SAFETY RECALL BULLETIN

WINDSHIELD WIPER MOTOR – SAFETY RECALL CAMPAIGN

No:	SR-16-010
		December, 2016
•	MODEL: 2011–2015 Outlander Sport / RVR

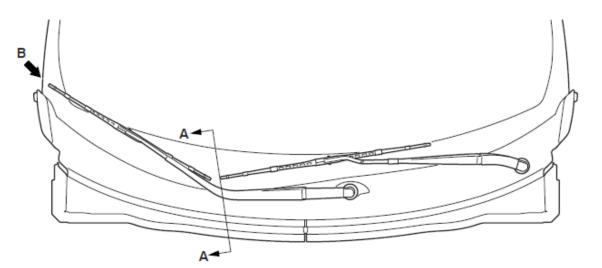
13. Verify that the new wiper motor has a breathing hole cap with a water proof cloth, as illustrated.

16. Fill the wiper link rod joint's resin cap with Multipurpose grease MZ100915EX (SAE J310, NLGI No. 2 or equivalent).
